Changes to Bid Information

CLIENT: DEKALB COUNTY DEPARTMENT OF WATERSHED MANAGEMENT
DEKALB COUNTY, GEORGIA

PROJECT: CHAMBLEE DUNWOODY ROAD WATER MAIN REPLACEMENT PHASE II

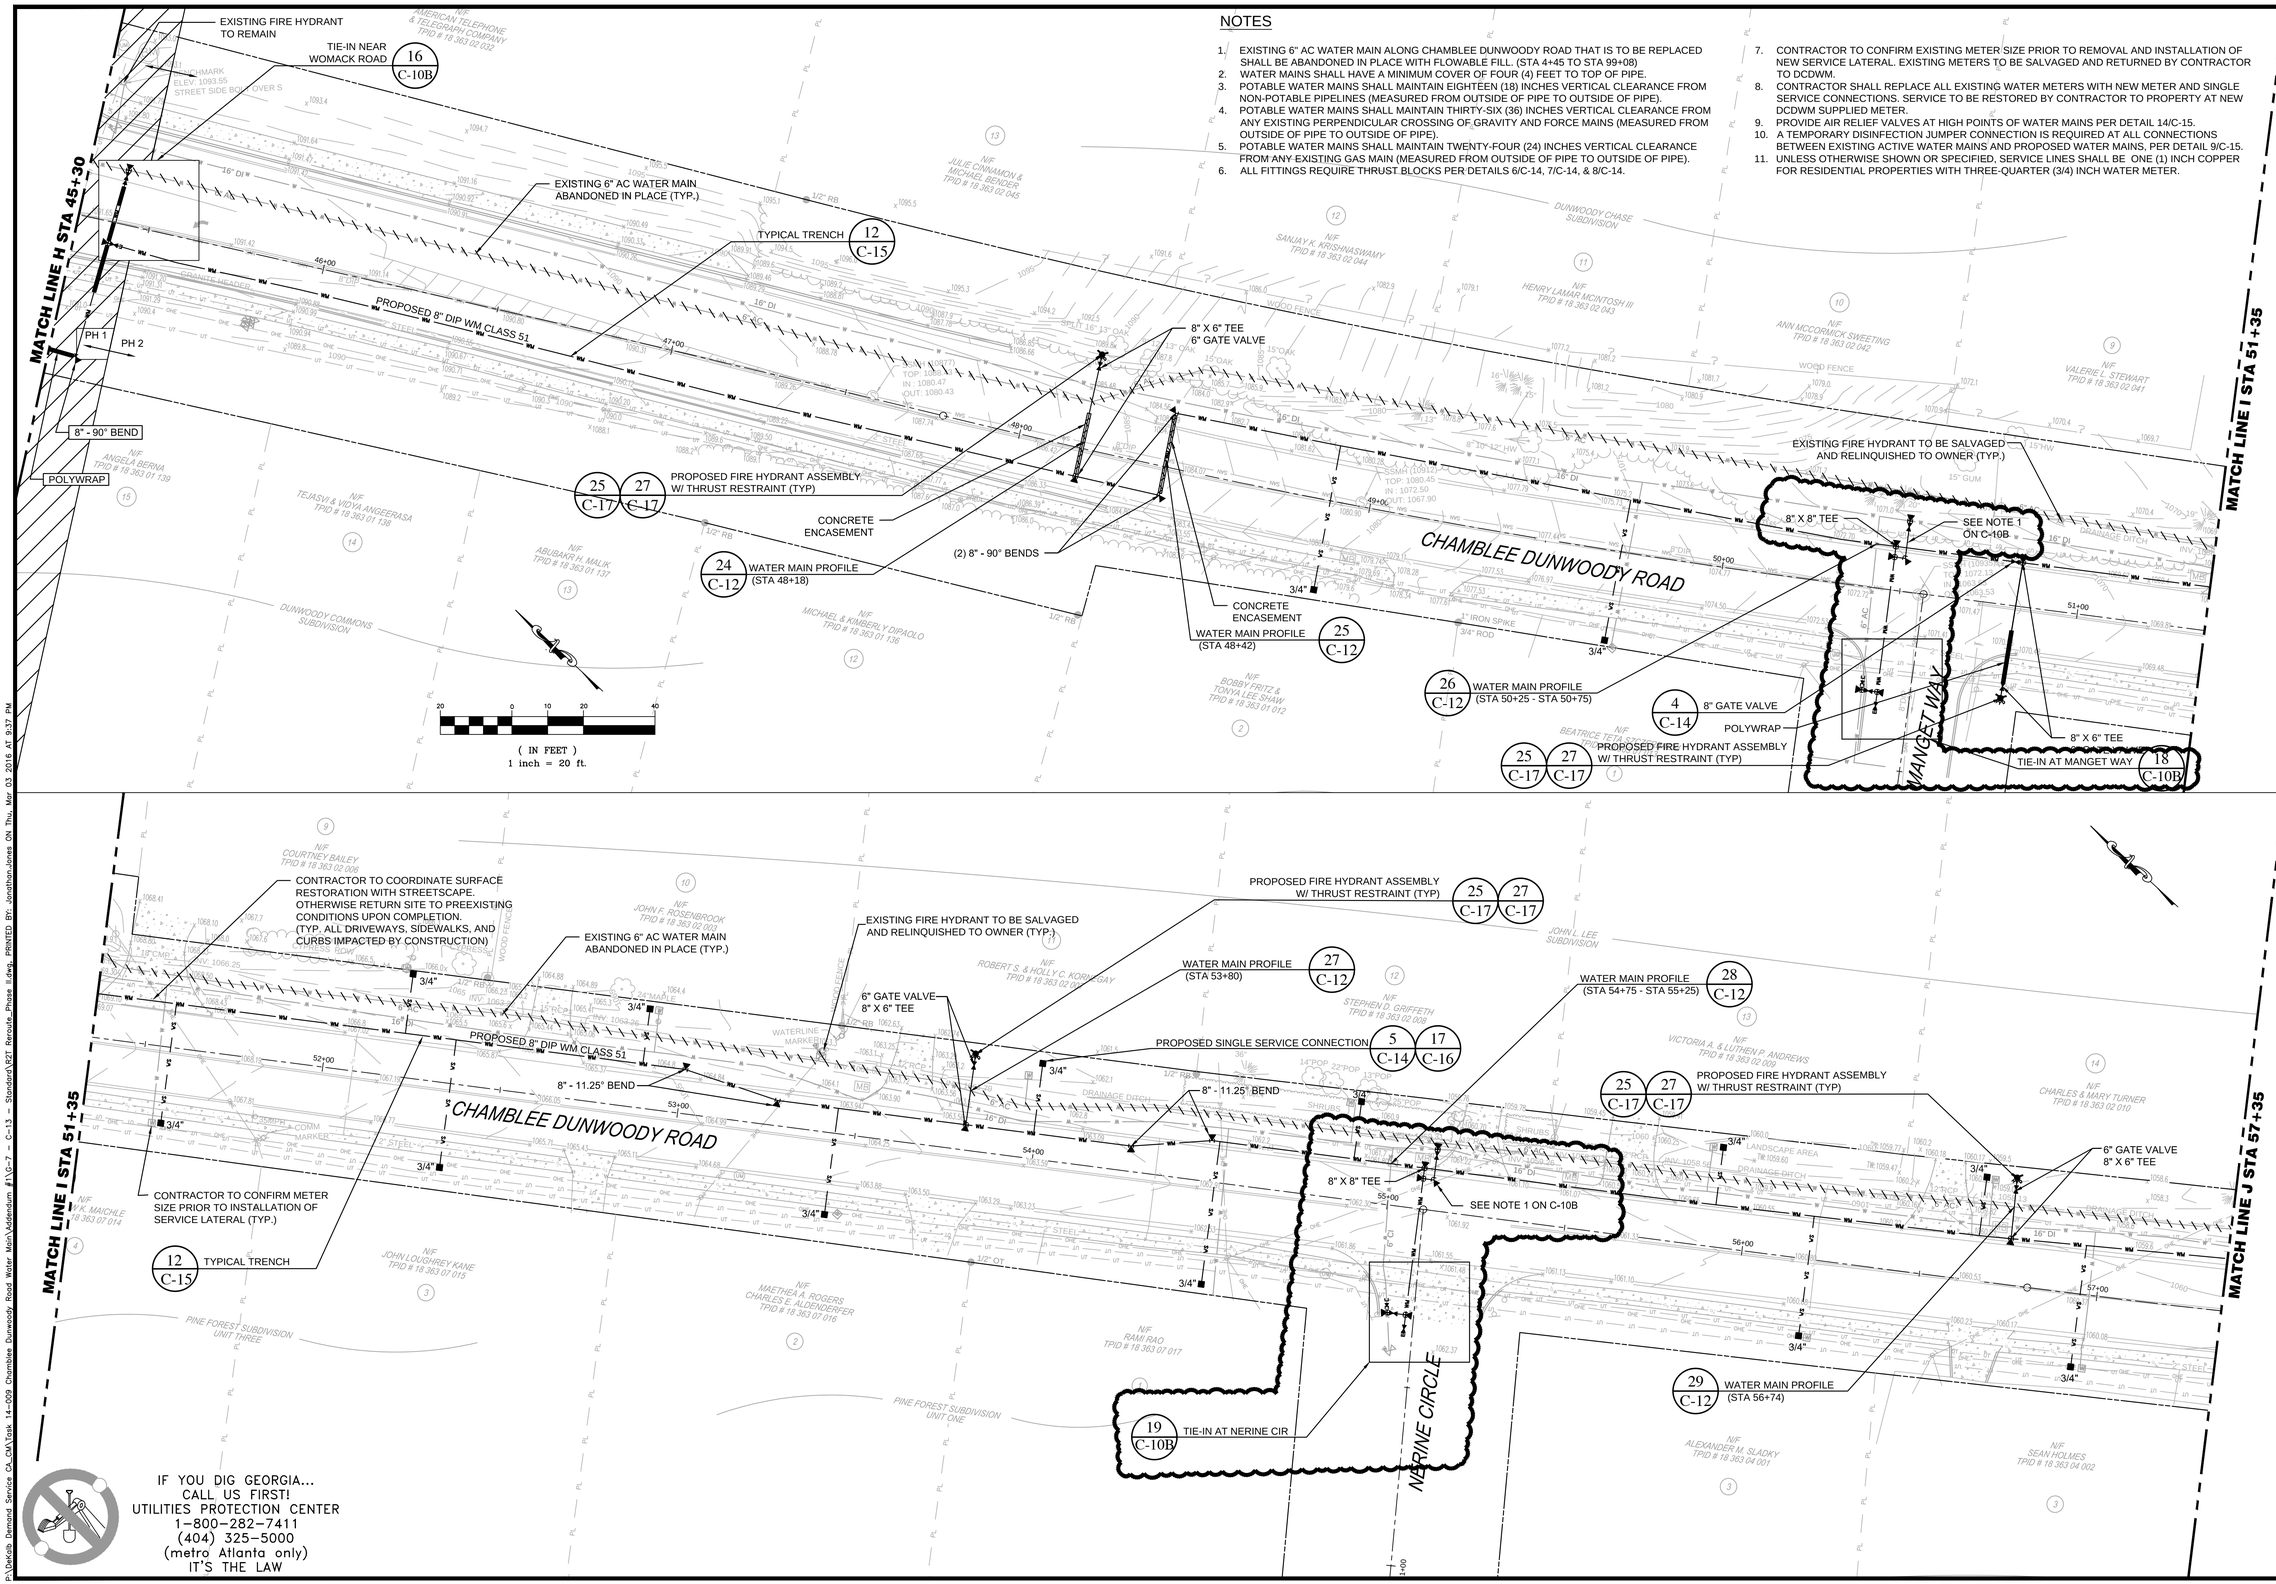
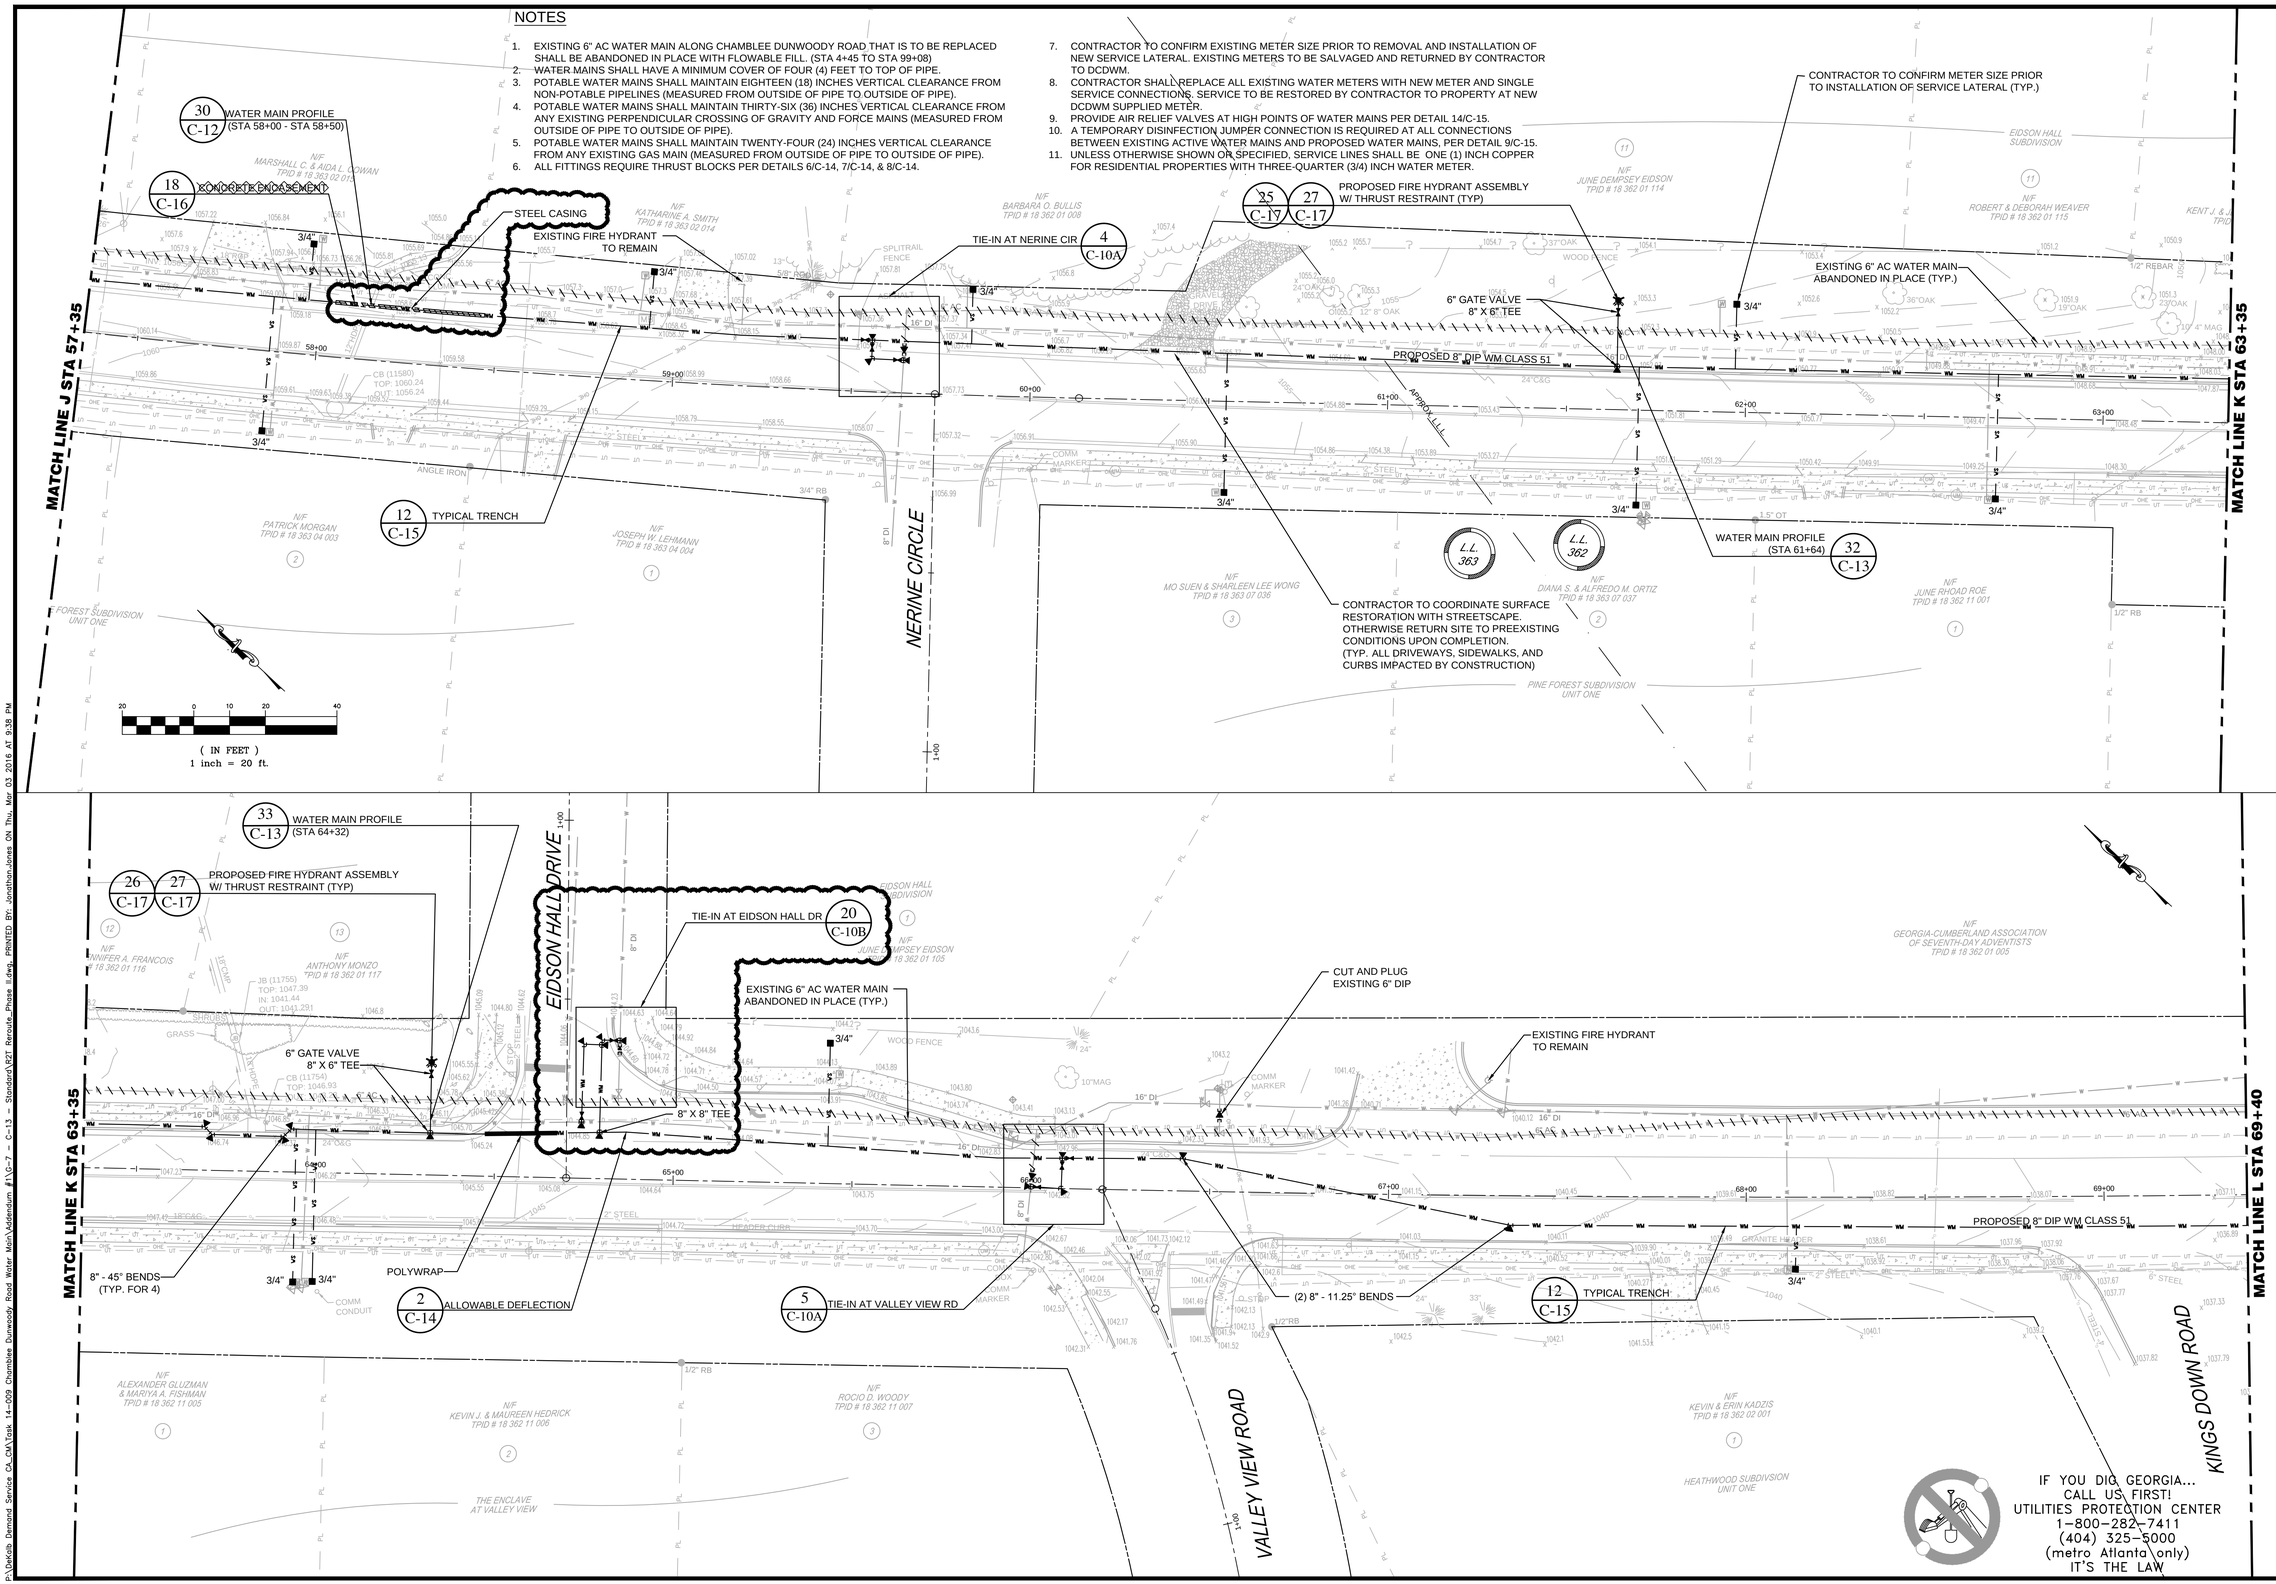
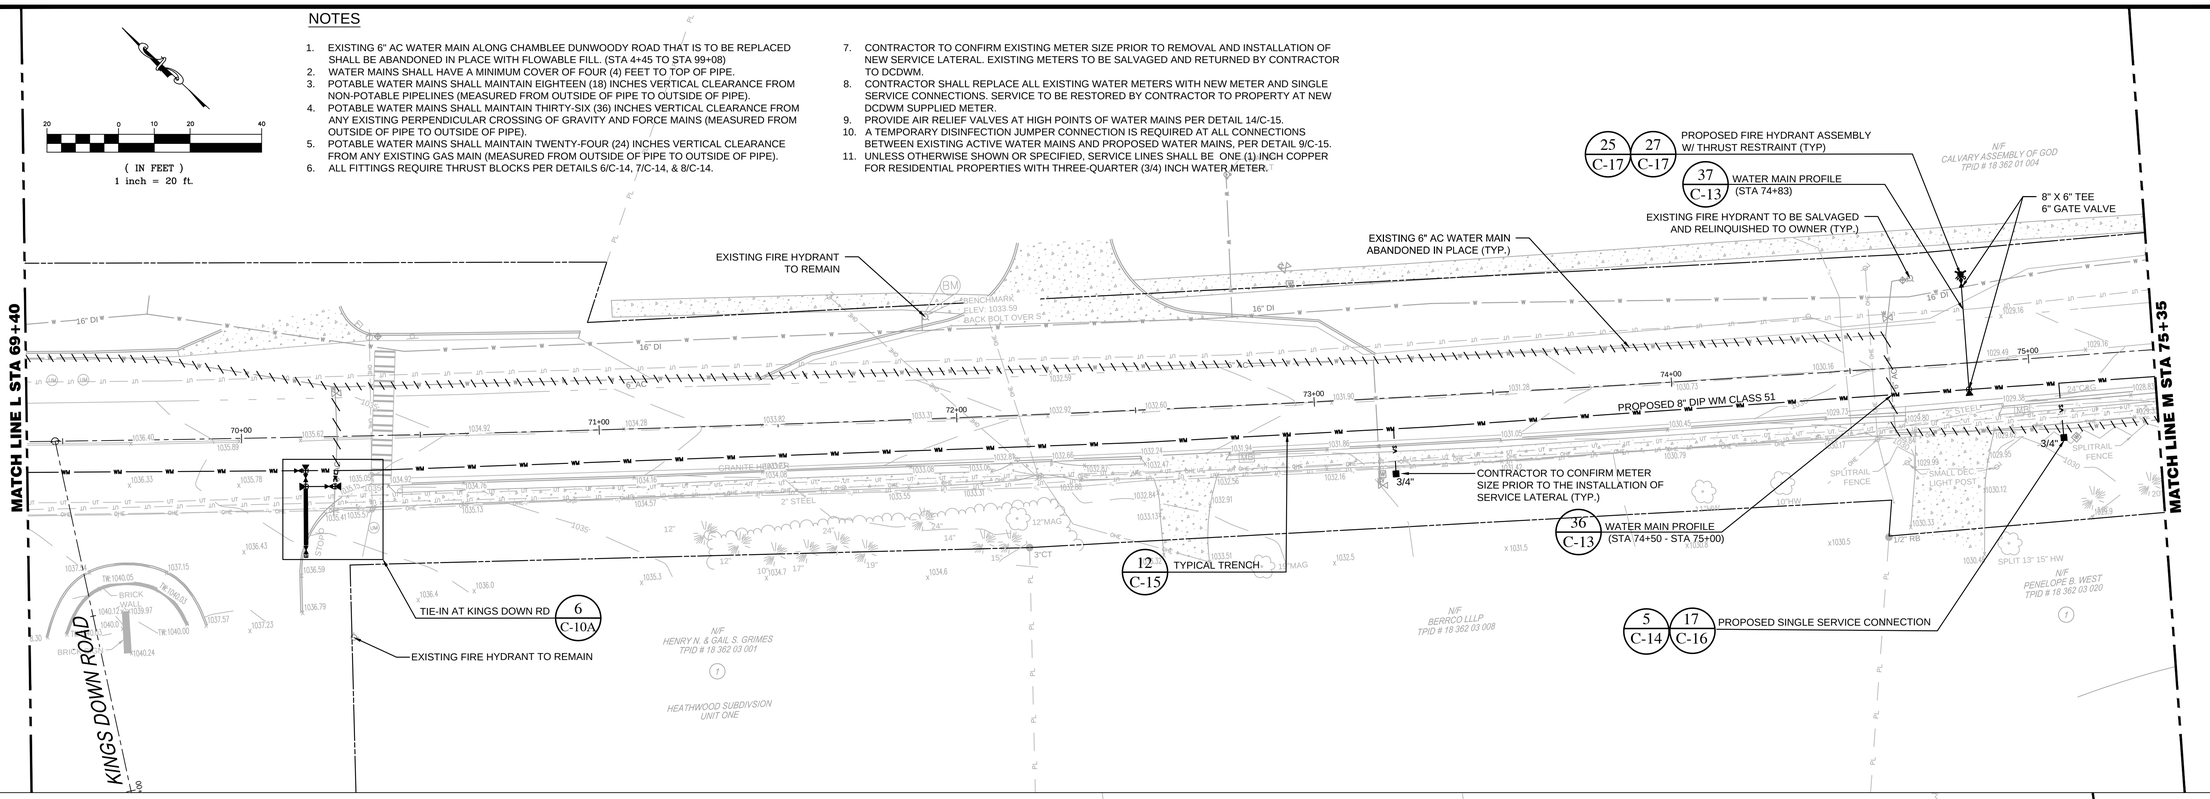
The changes are generally of two types: 1. 16"x8" Tapping Sleeves and Valves were added at several locations along the alignment. 2. Concrete encasement was generally removed and replaced with either no special handling or a jack and bored steel casing to avoid impacts to existing or proposed infrastructure. In some cases, it was determined that concrete encasement should not be altered.

The bid items indicate that there will be 270 LF of Jack and Bore operation to be performed. However the plans do not indicate ANY jack bore operation to be performed anywhere. It is imperative to know WHERE you intend to jack and bore as the location can drastically change the price. For instance if I have to Jack and Bore FROM the middle of Chamblee Dunwoody TO the middle of Chamblee Dunwoody, then the expense of traffic control, excavation and site restoration in the middle of a busy street will be way different than if I have to Jack and Bore across a side street with both of my pits off the road in the dirt.

3. The plan does not specify the location of jack and bore. What is the location?

Response: The drawings have been updated to reflect the locations of the jack and bore for the 8-in DIP WM and water service lines. These locations are indicated on the plan view, the Insets (where appropriate), and the profile views.

For the WM, in addition to the 8-inDIP pipe, the pay items applicable for each case of Jack and Bore are:
615-1000 Jack and Bore Pipe, 8”DIP, and
670-7000 Steel Casing, 18-Inch.

For service lines, in addition to the copper tubing, the pay item applicable to each case of Jack and Bore is:
615-1002 Jack and Bore Pipe, Copper ¾”, 1”, or 2”.

Service connections will direct bore and not be contained in a carrier pipe. All long-side services shall be jack and bored.
